Soil and Water Management Plan

Jandra Quarry

Holcim Australia Pty. Ltd.

Figure 1 Approved Development

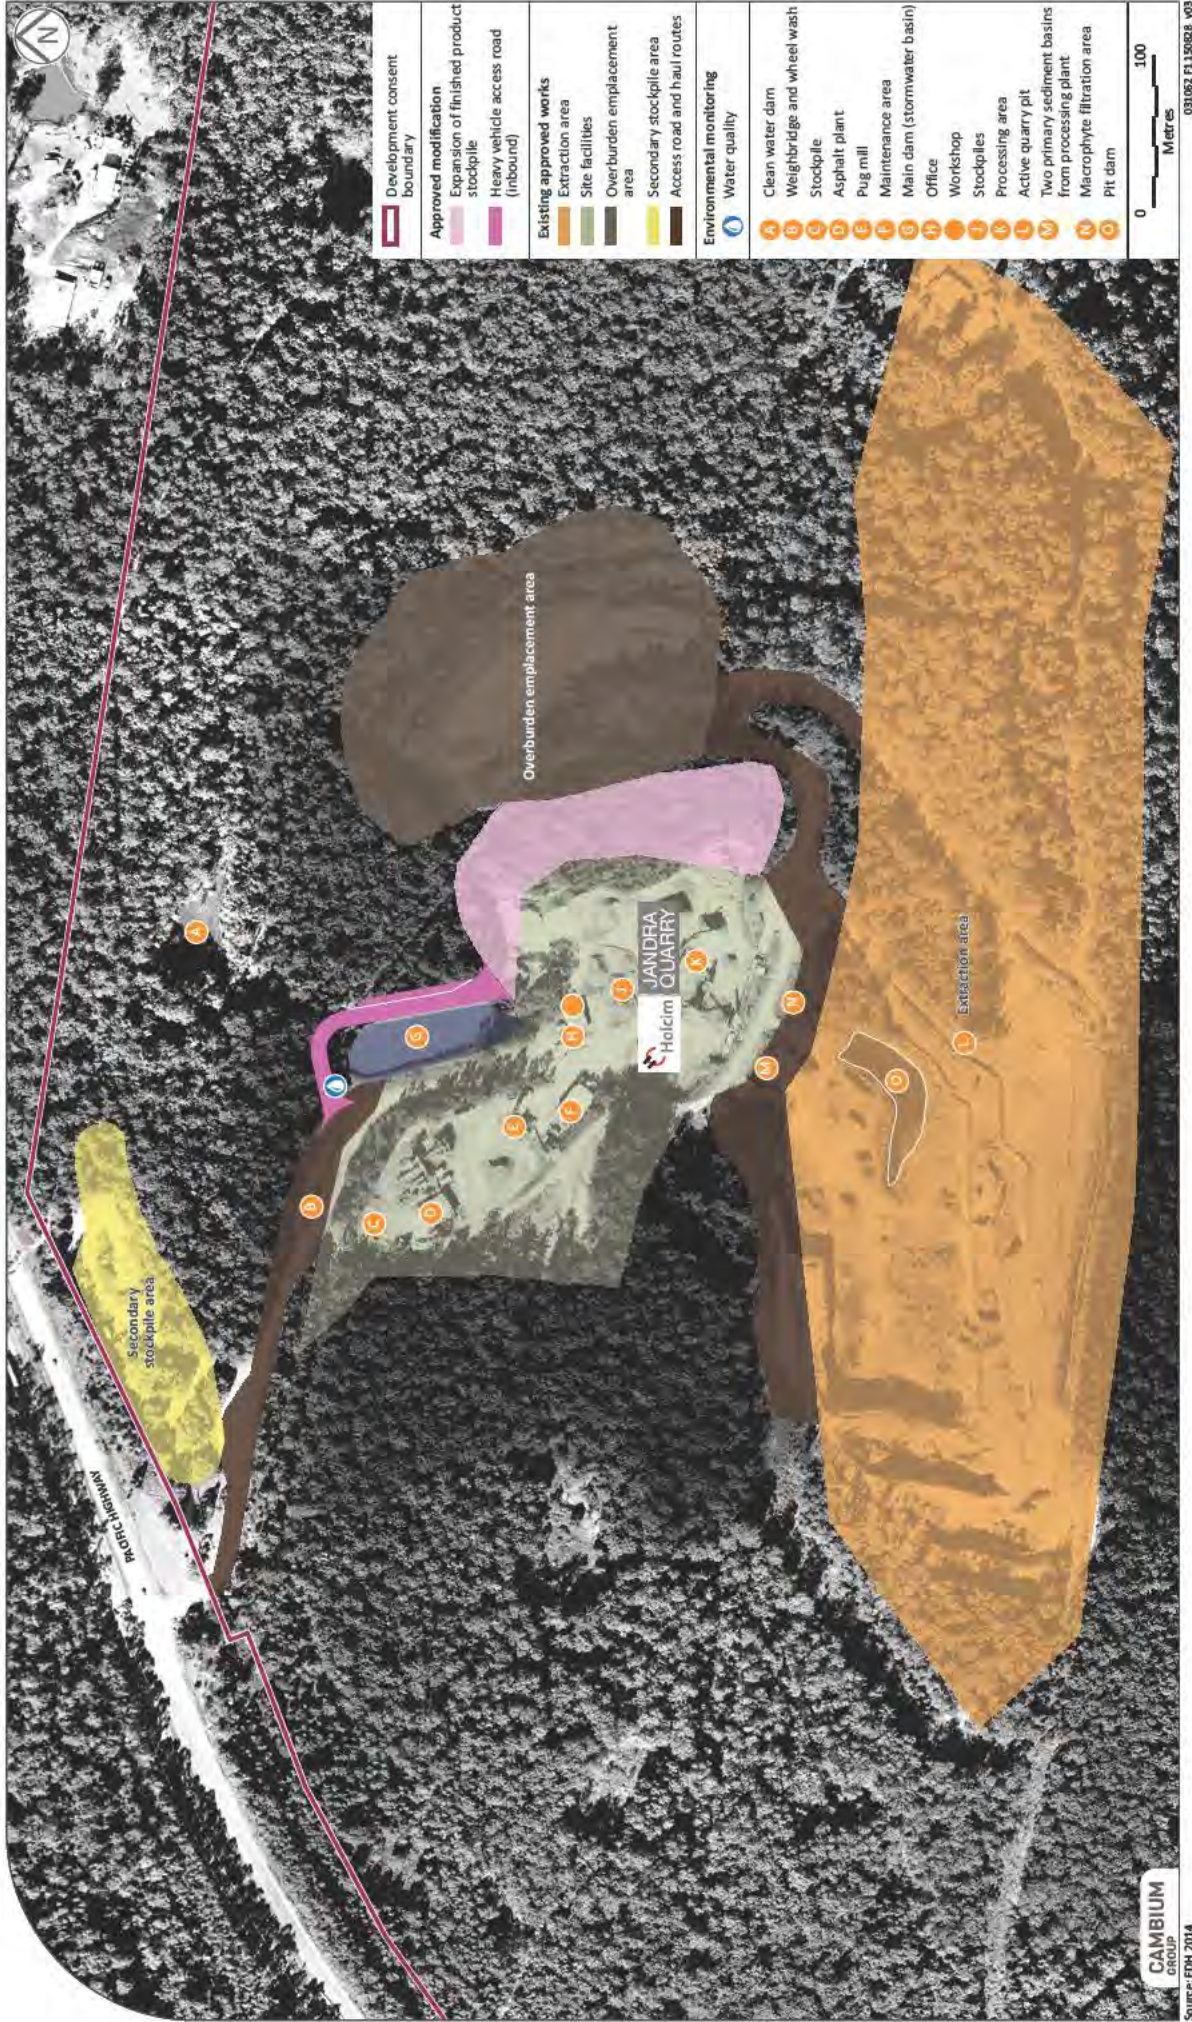
requirements must be included in the properties harvestable right calculation, along with the capacity of all clean water dams. It is noted that the clean water dam as shown in Figure 1 has a capacity of 4 ML. DPI Water considers clean water storages as described in the SWMP to be within the properties harvestable right, as such additional licences are not required.
